**ATTACHMENT 2 TO TXX-06125**  
**RESPONSES TO REQUESTS FOR ADDITIONAL INFORMATION**  
**FOR THE REPLACEMENT STEAM GENERATOR SUPPLEMENT**  
**TO TXU POWER'S OTHER THAN LOSS OF COOLANT**  
**ACCIDENT ANALYSIS METHODOLOGIES**

**July, 2006**

Figure 2-1. Comparison of  $\Delta 76$  design parameters – Total Secondary Side Mass

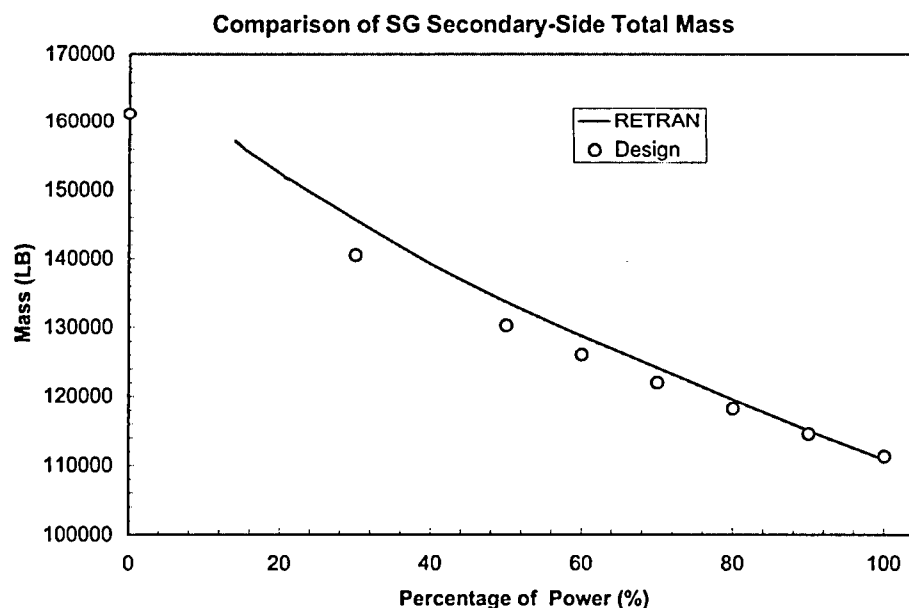
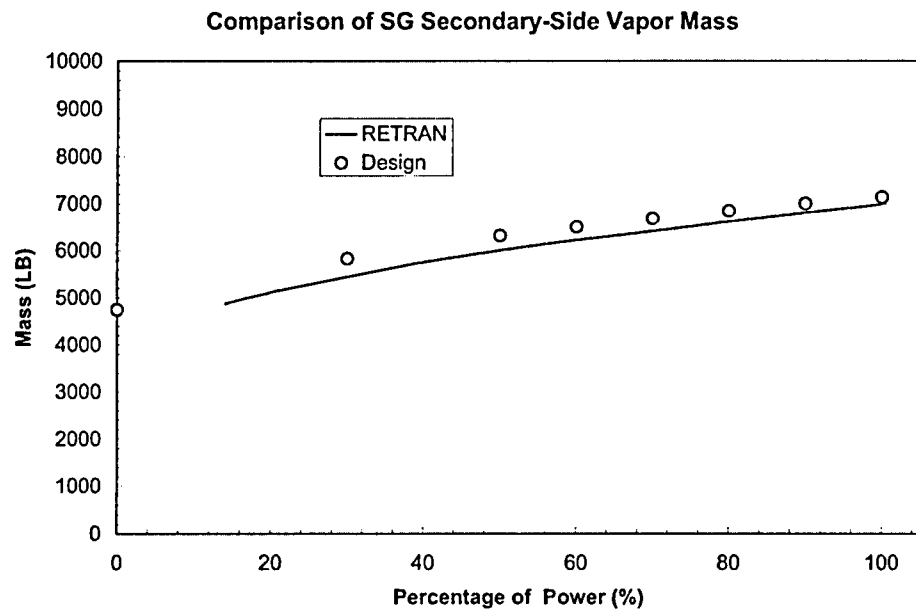
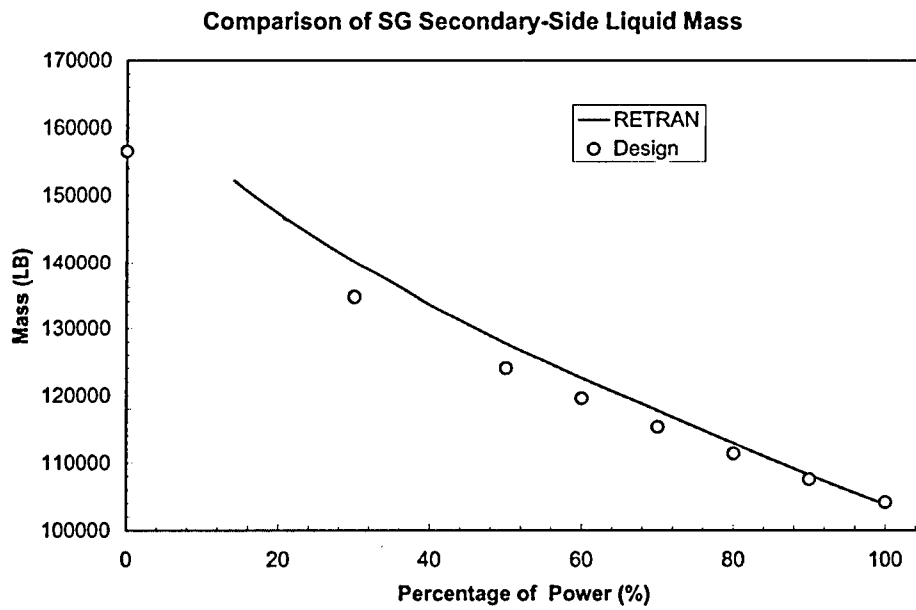
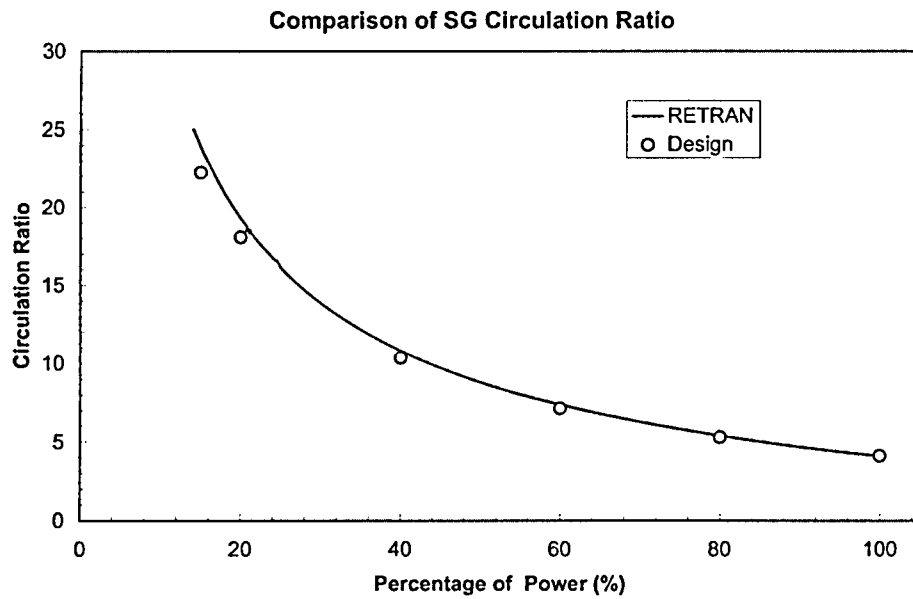
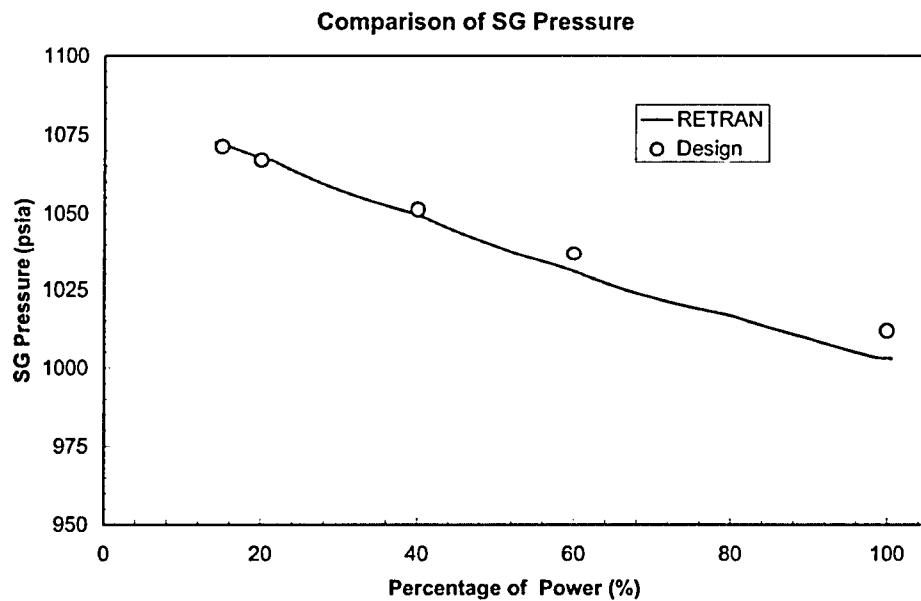
- a. Provide the vendor design data and model results that were used to validate the model's ability to reproduce steady-state conditions. Charts and tables are acceptable.**
- b. Explain what evidence provides reasonable assurance the model will accurately reproduce transient conditions at CPSES.**
- c. Given the differences in design and modeling between the D-4 and  $\Delta 76$  steam generators, the staff believes comparing the results of the two sets of analyses is problematic and may not be a true evaluation of the new modeling and methodology. Please provide comparisons of  $\Delta 76$  steam generator analysis to those of similar design and size.**

- a. The data in the Table 2-1 is a summary of a comparison of relevant design data from the vendor's design tool and the RETRAN-02-based stand-alone  $\Delta 76$  SG model for full power, steady-state operating conditions. As may be observed, the results from the full power RETRAN-02 stand-alone model compare quite well to the vendor-supplied design data.**

Additional evaluations were then performed to assess the adequacy of the model for conditions other than full power operations. Forcing functions for the Reactor Coolant System flow rate and hot leg temperature and the main feedwater flow rate and temperature were used with the stand-alone steam model to simulate a gradual downpower transient. Design data at various power levels were extracted from design input data provided by the vendor specifically for this purpose. Comparisons of relevant parameters are presented in Figures 2-1 through 2-5. As may be observed, the stand-alone  $\Delta 76$  steam generator model provides an adequate representation of vendor-supplied design data throughout the range of normal operating conditions.

Figure 5-1. Comparison of results for an increase in feedwater flow transient with  $\Delta 76$  and D4 steam generator designs – normalized reactor power

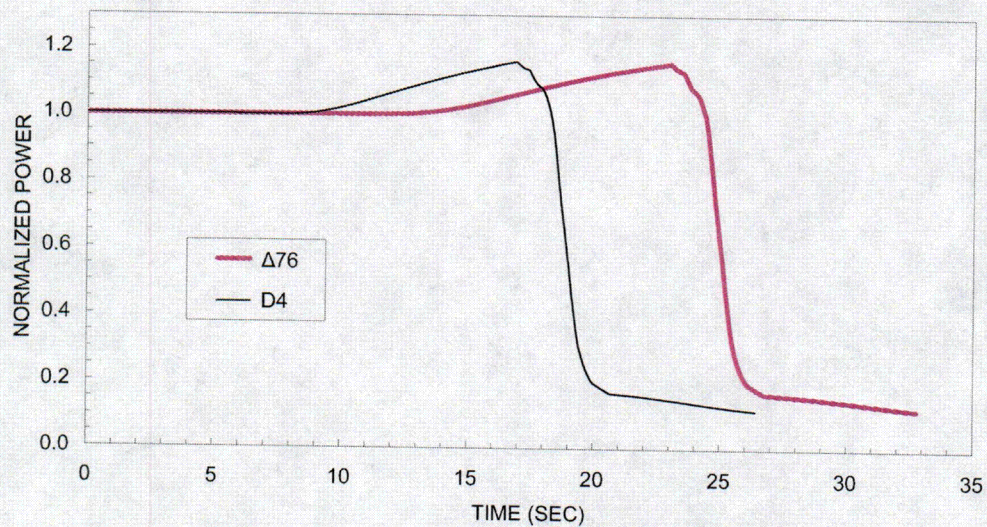
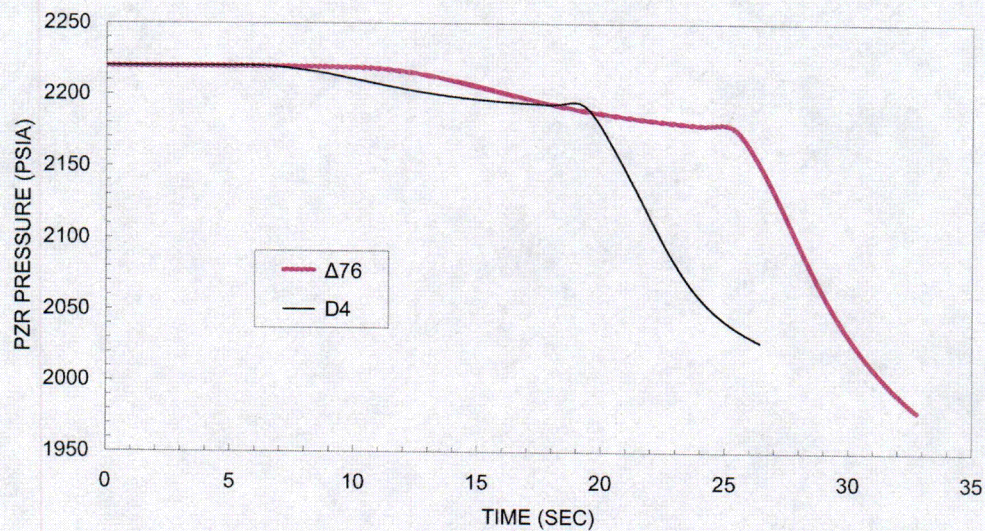
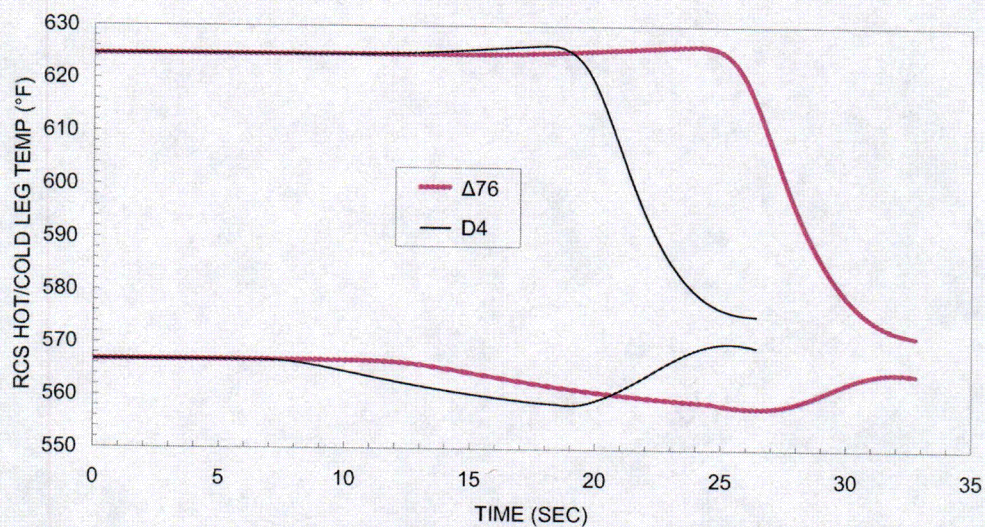
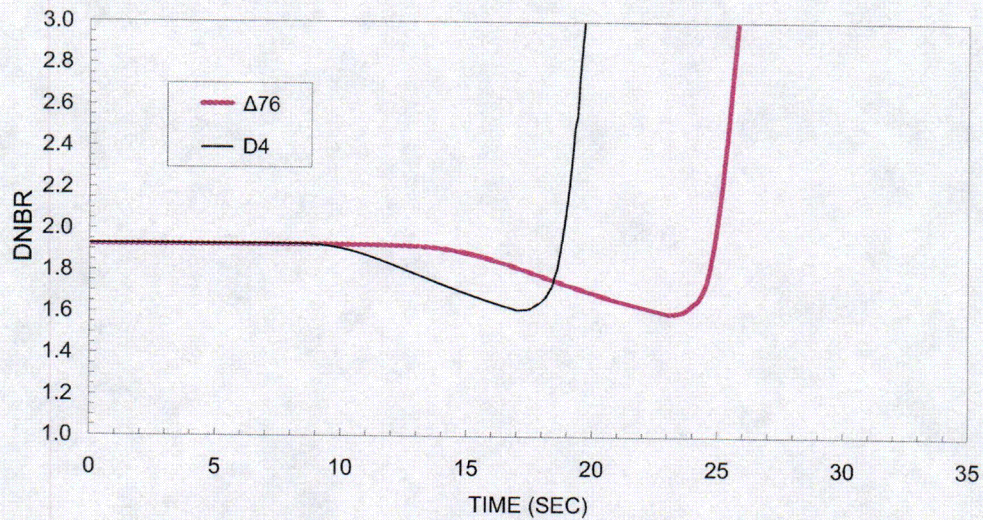
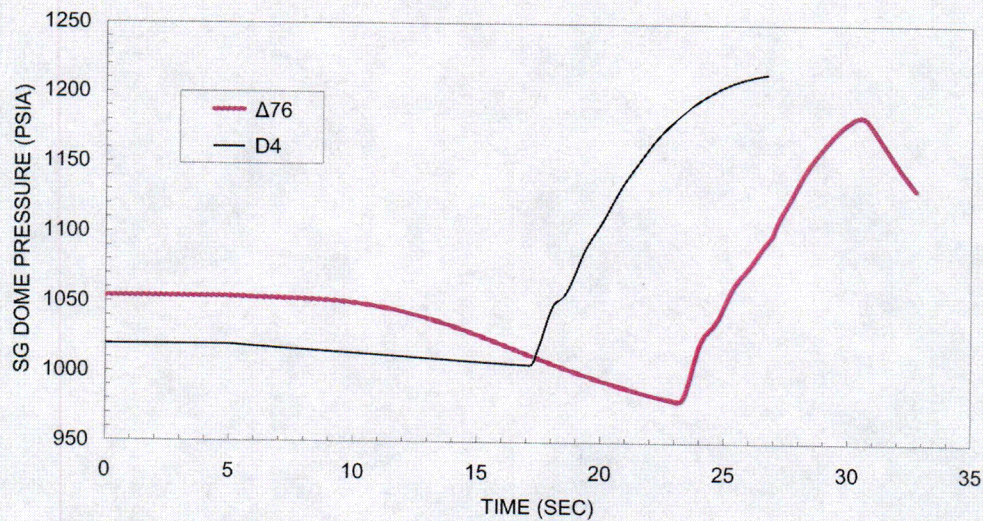
**In Section 3.3 of ERX-04-005 (Ref. 2) the licensee provides a qualitative discussion of the impact of the  $\Delta 76$  steam generator on the Non-LOCA transients. The licensee repeatedly uses the statement, "The incorporation of the  $\Delta 76$  steam generator design does not result in a transient response that is significantly different from the current CPSES analyses." Given the responses to RAI Questions 1 and 3 for RXE-91-001-A the staff would expect the potential for a significant difference in transients in which feedwater flow or temperature is affected. Given the differences in design and modeling between the D-4 and  $\Delta 76$  steam generators, the staff believes comparing the results of the two sets of analyses is problematic and may not be a true evaluation of the new modeling and methodology. To determine the adequacy of existing methodologies, provide a quantitative discussion of the impact of the  $\Delta 76$  steam generator on the Non-LOCA transients. Include how the transient progresses from start to finish.**

A comparison of the Sequence of Events for these two analyses is provided in Table 5-1. Comparative plots of relevant parameters are shown in Figures 5-1 through 5-5. The same trends are observed in each analysis. The effects of the larger heat transfer area of the  $\Delta 76$  steam generator model are apparent in the initial conditions shown in Figure 5-5, where, for the same RCS average temperature, the steam generator secondary side pressure is higher.

As previously noted, the effects of the feedwater temperature decrease in the  $\Delta 76$  steam generator design lag the effects seen with the D-4 steam generator design. The rate of power increase is faster in the D-4 analysis, resulting in a slightly higher overshoot in the reactor power between the time the overpower reactor trip setpoint is reached and control rods begin to drop into the reactor core.
